Our Reference: NP24.131  
TCC Reference: MCU25/0035  
RB.MM

### **Response to Information Request**

**Development Application for Material Change of Use – Health Care Services (Medical Centre)  
369 Mount Low Parkway, Bushland Beach and formally identified as Lot 2 on RP744351**

Title : SITE PLAN  
Job No:  
2025-055-C  
Date: 27.02.25 Drawn: N.H Drawing No: Rev.  
Scale: As indicated Designed: N.H DD 02 2

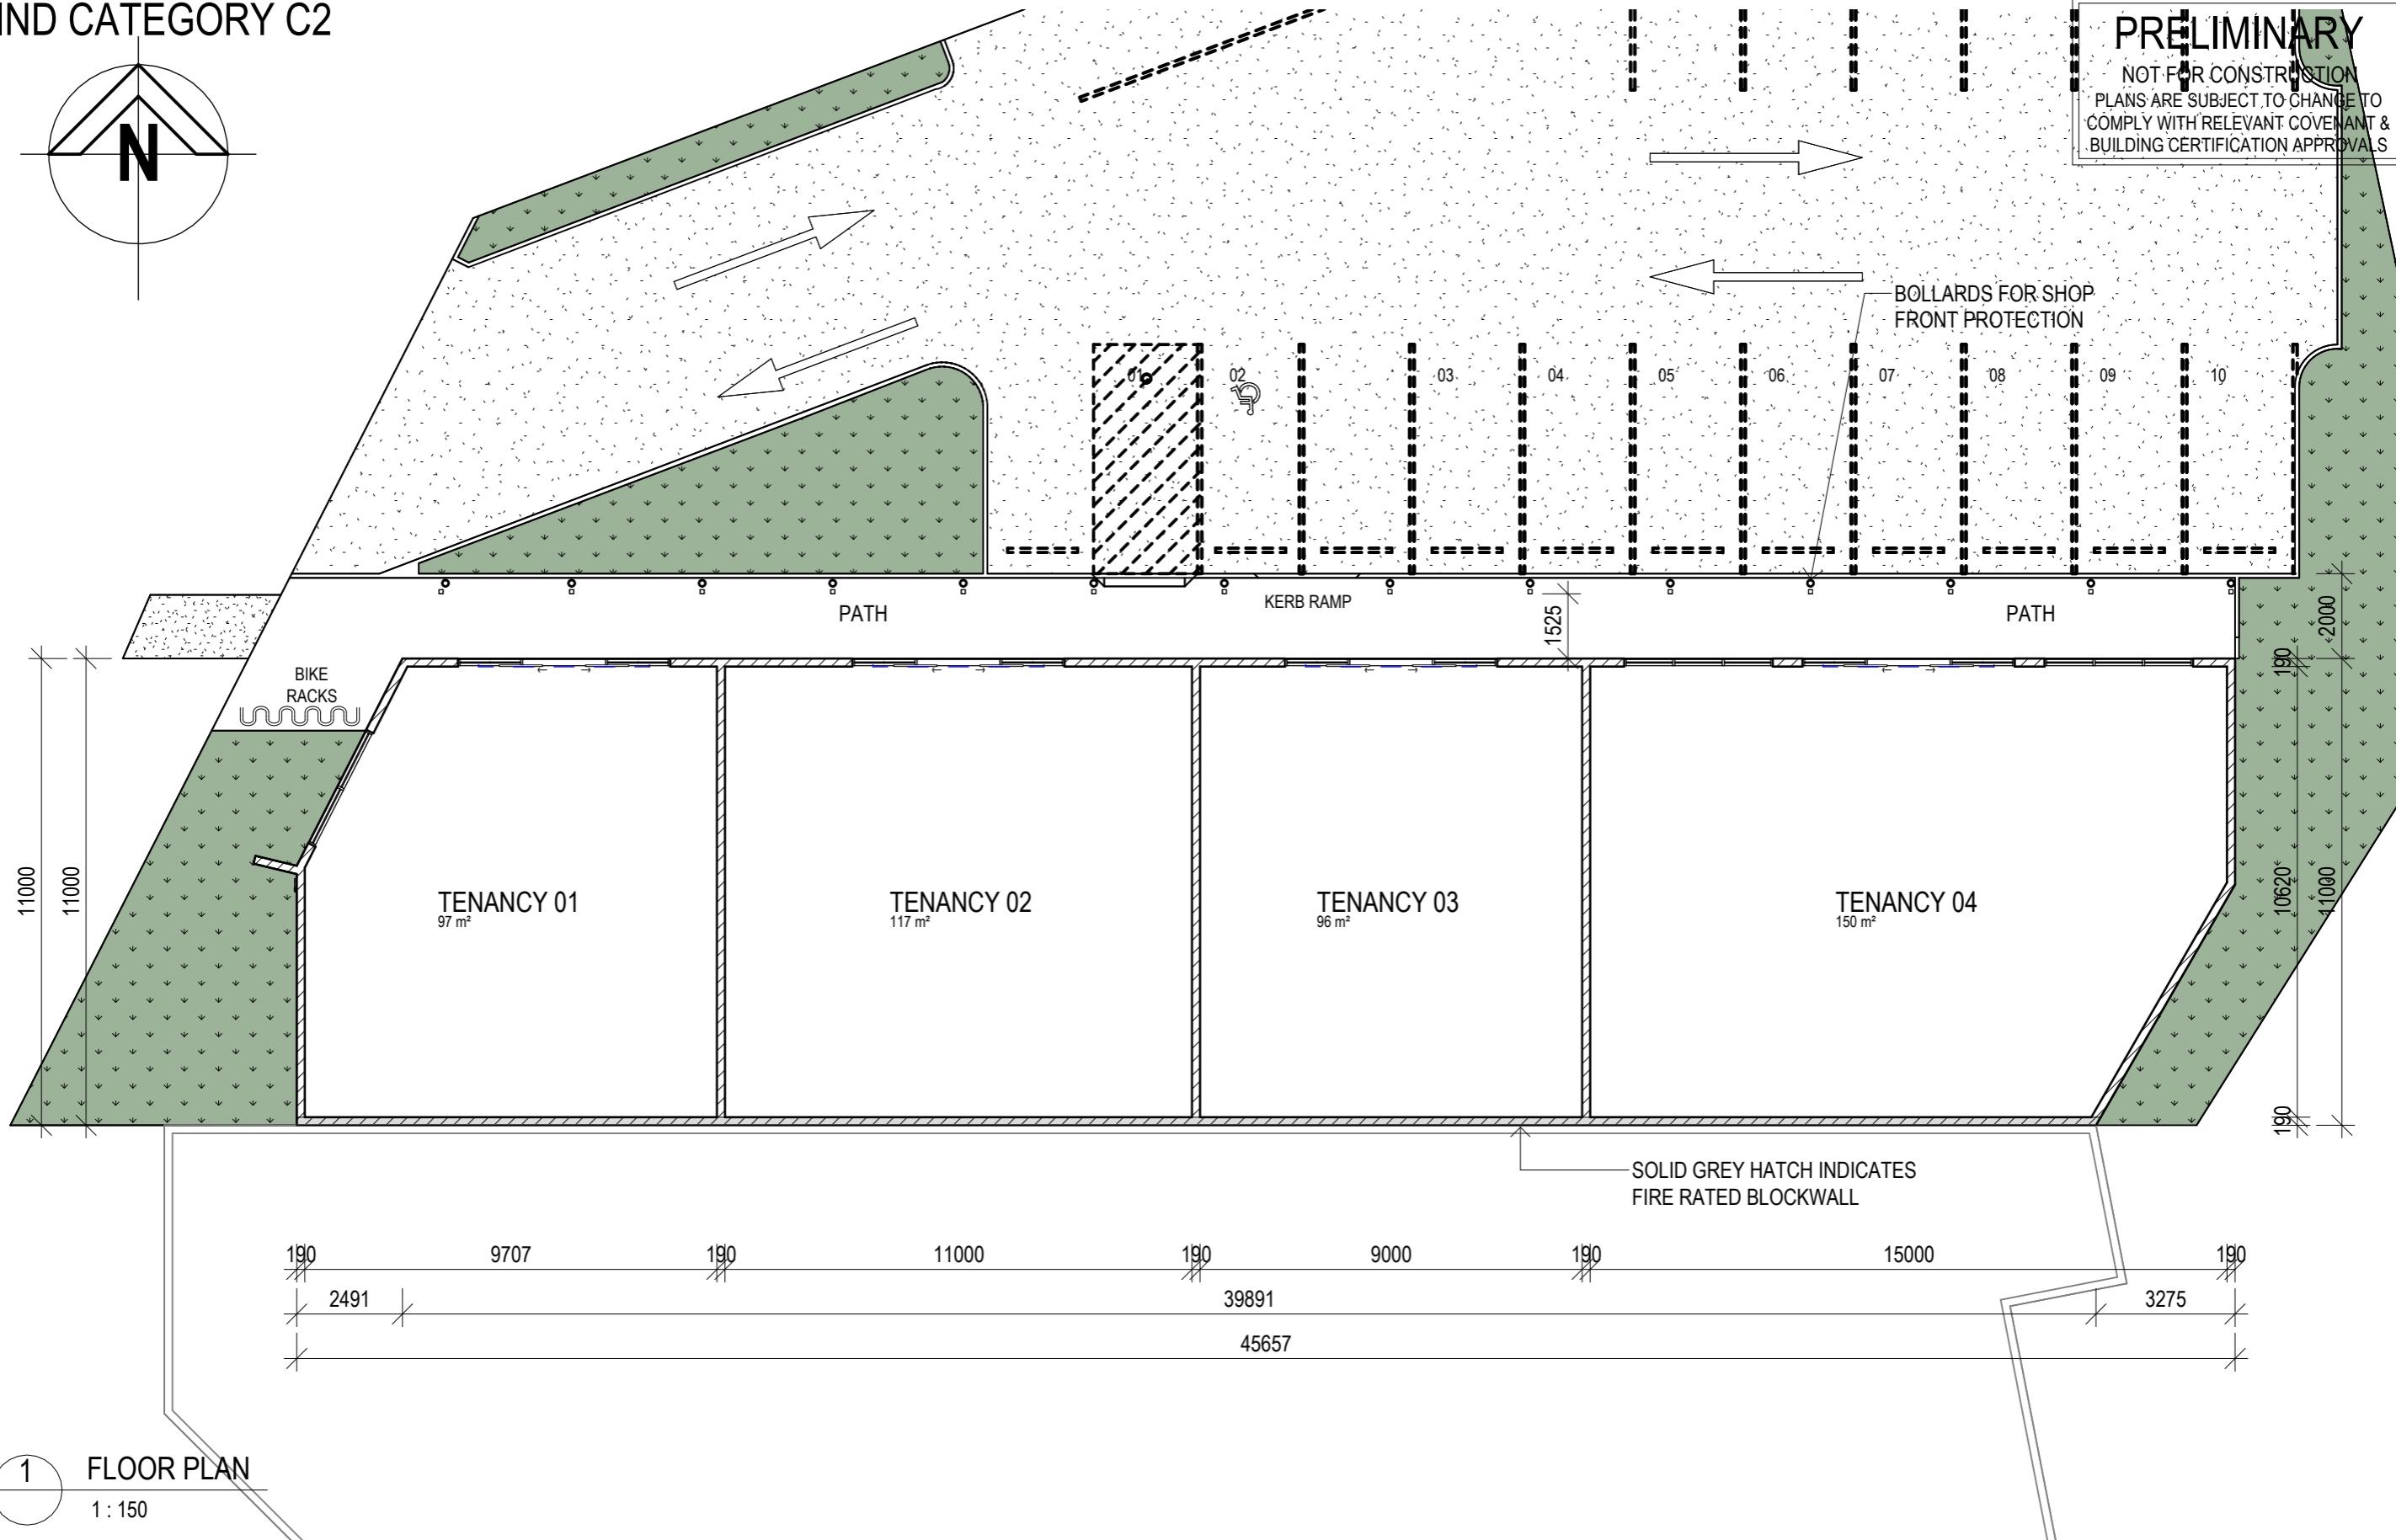
The applicant is requested to provide amended plans detailing improved pedestrian and cyclist connectivity between the proposed development and the existing pedestrian footpath on Mount Low Parkway. Pedestrian and cyclist pathways are to be separated from any areas traversable by motor vehicles.

In response to this item, amended plans have been provided (refer **Attachment 2**) demonstrating improved pedestrian and cyclist connectivity between the proposed development and the existing pedestrian footpath along Mount Low Parkway.

Specifically, a new pathway is provided connecting the proposed building to the existing footpath network along the Mount Low Parkway road frontage.

The proposed bike rack has been relocated to the western side of the building and is accessible via the proposed pathway, ensuring separation from on-site vehicle movements and avoiding potential conflicts.

In accordance with Council's request, the proposed pathway is suitably separated from all areas traversable by motor vehicles.

Title : SITE PLAN  
Job No:  
2025-055-C  
Date: 27.02.25 Drawn: N.H Drawing No: Rev.  
Scale: As indicated Designed: N.H DD 02 2

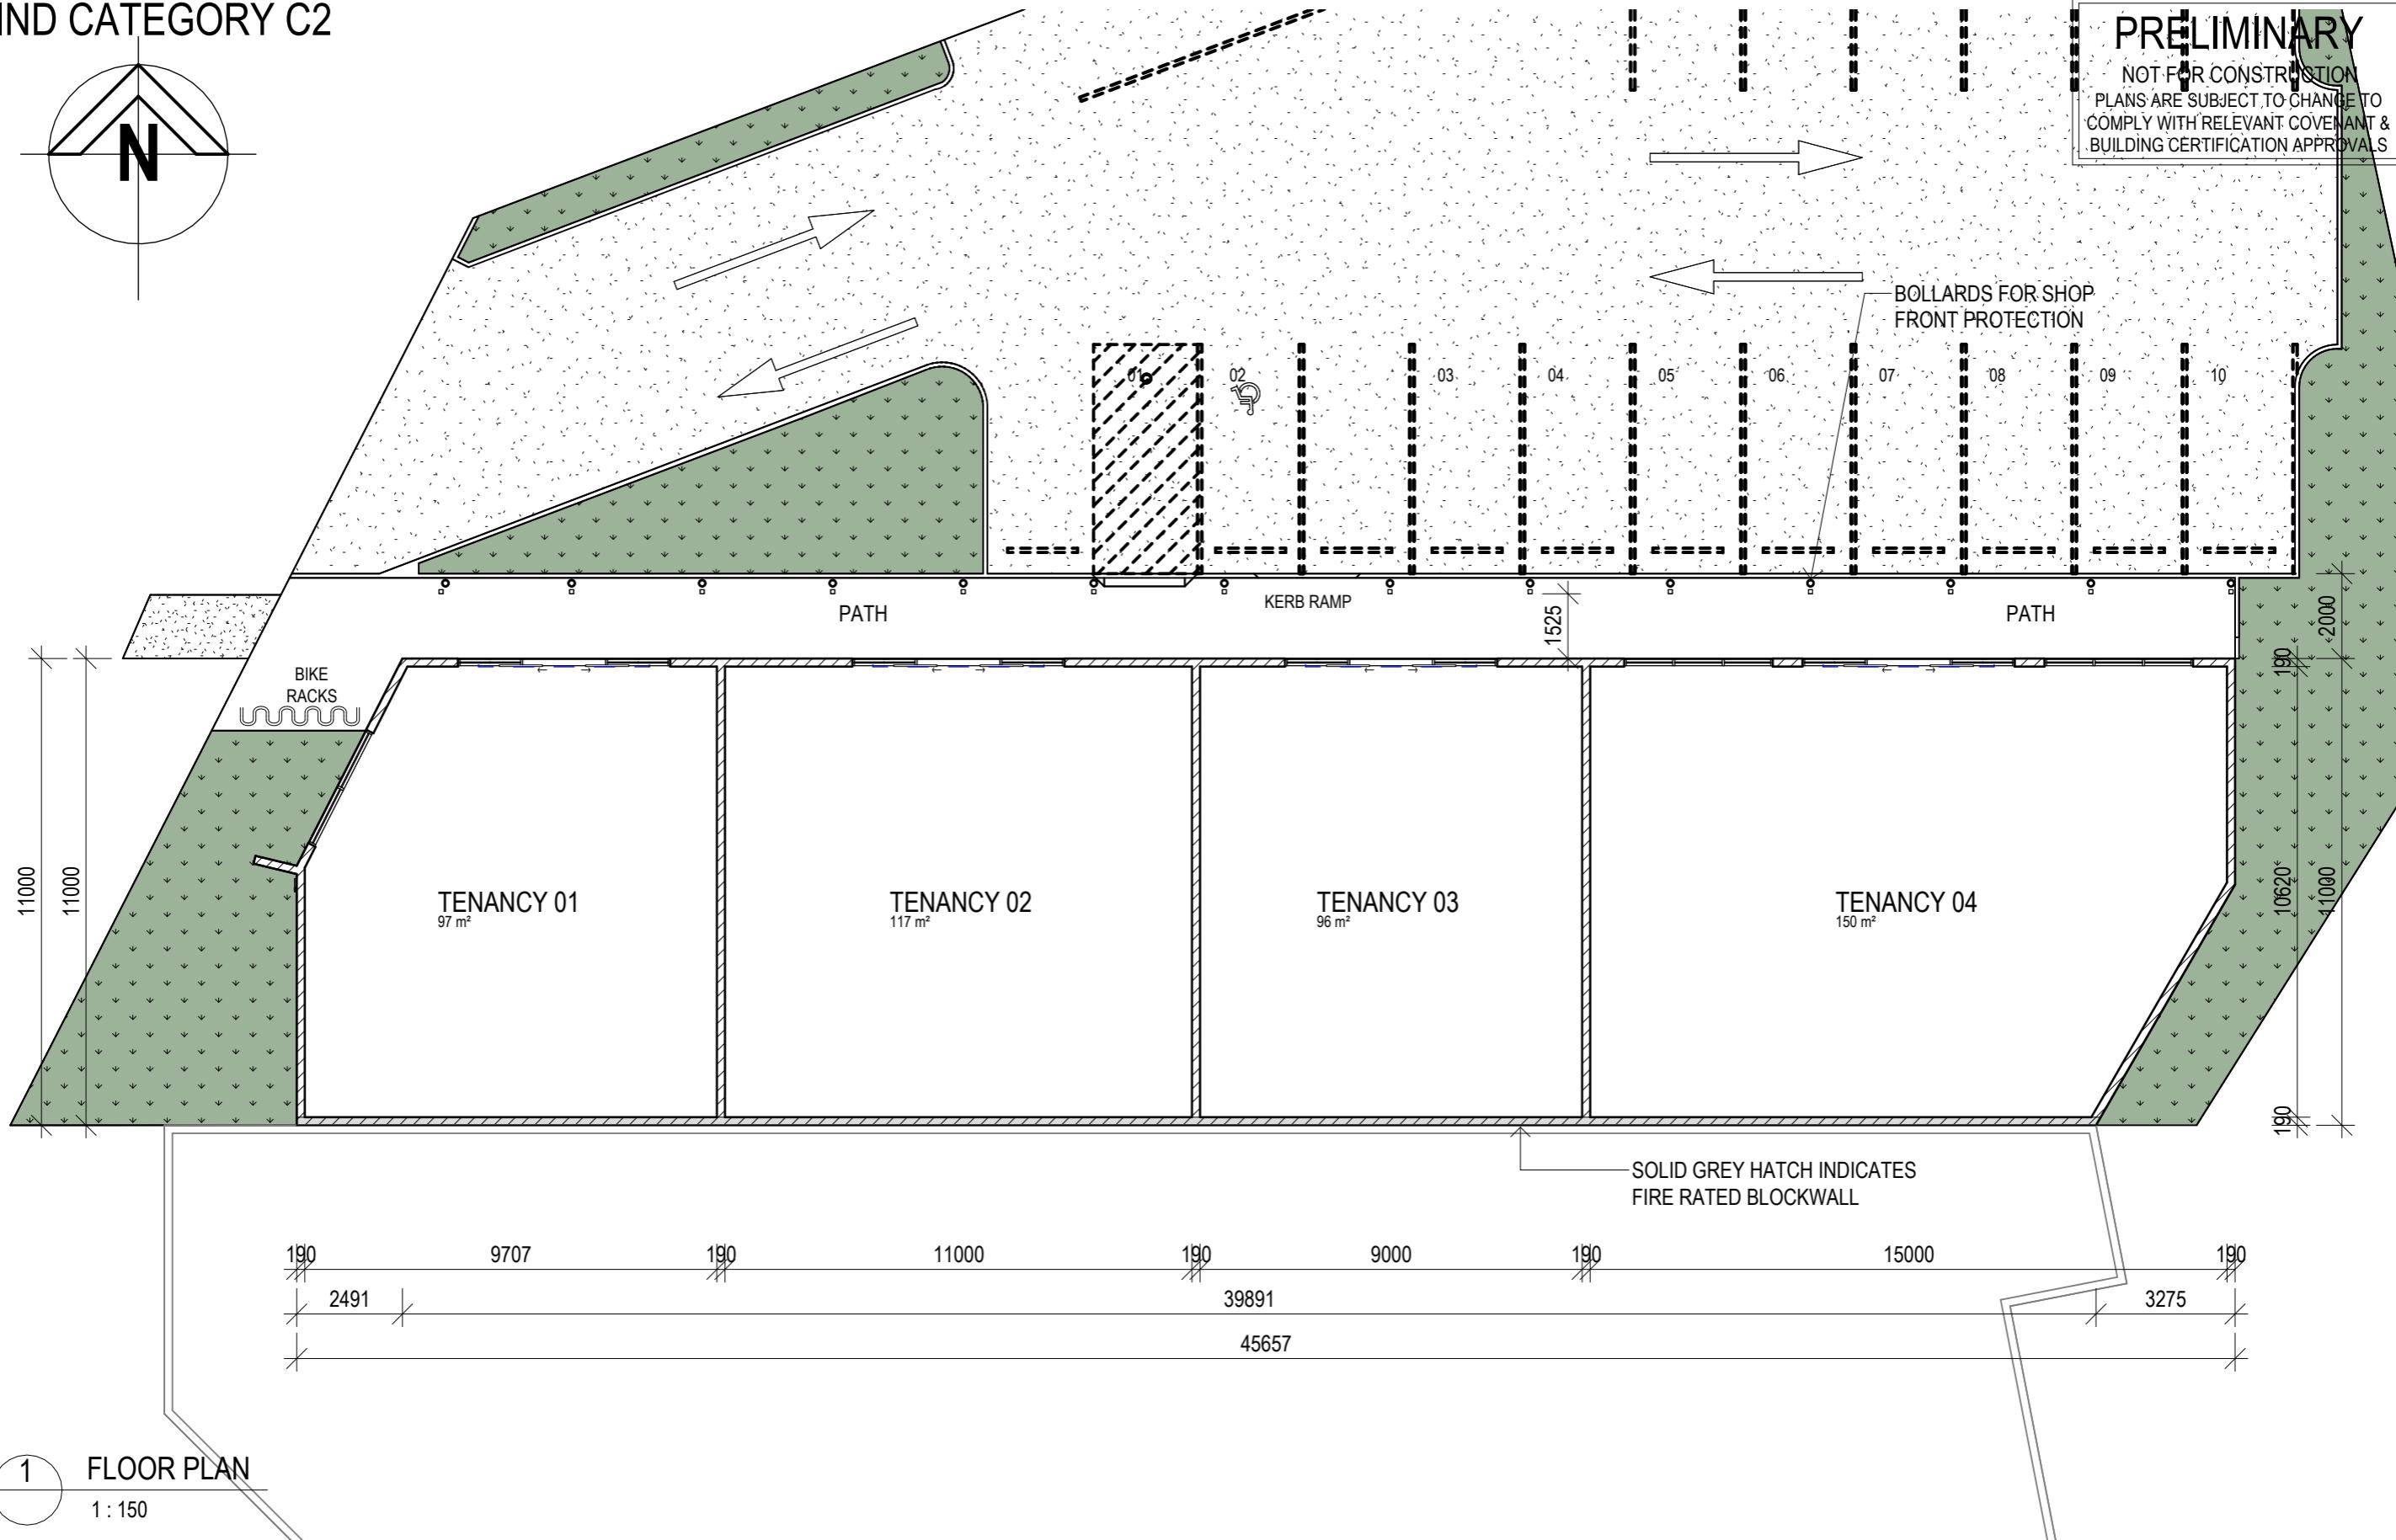
- Address trip generation rate, access and sight line distance, conflict of access arrangement with existing on street parking and council bus zone bay and potential impact on the nearby roundabout and access improvement recommendations, as required.
- Demonstrate safe forward entry and exit for commercial vehicles with adequate sight distances, avoiding reverse movements.
- Confirm sufficient queuing capacity at the roundabout access to on-site parking, in line with the RTA's Guide to Traffic Generating Developments.
- Demonstrate consideration for situations where both PWD parking spaces are occupied, and an emergency ambulance is present at the site.

To ensure appropriate access arrangements and to improve road safety outcomes, the development plans have been amended to remove 1 on-street parking space, currently located to the property frontage. Further, it's proposed that the existing bus stop currently impeding on the site's frontage be relocated to the north of the roundabout.

A dedicated on-site ambulance bay is provided to the northern side of the car park and does not rely on or conflict with people with disabilities (PWD) parking spaces. The plans have been amended to remove one surplus PWD space, resulting in compliance with the relevant Australian Standards (AS2890).

The development provides a total of 18 on-site car parking spaces, which exceeds the minimum requirements of the planning scheme.
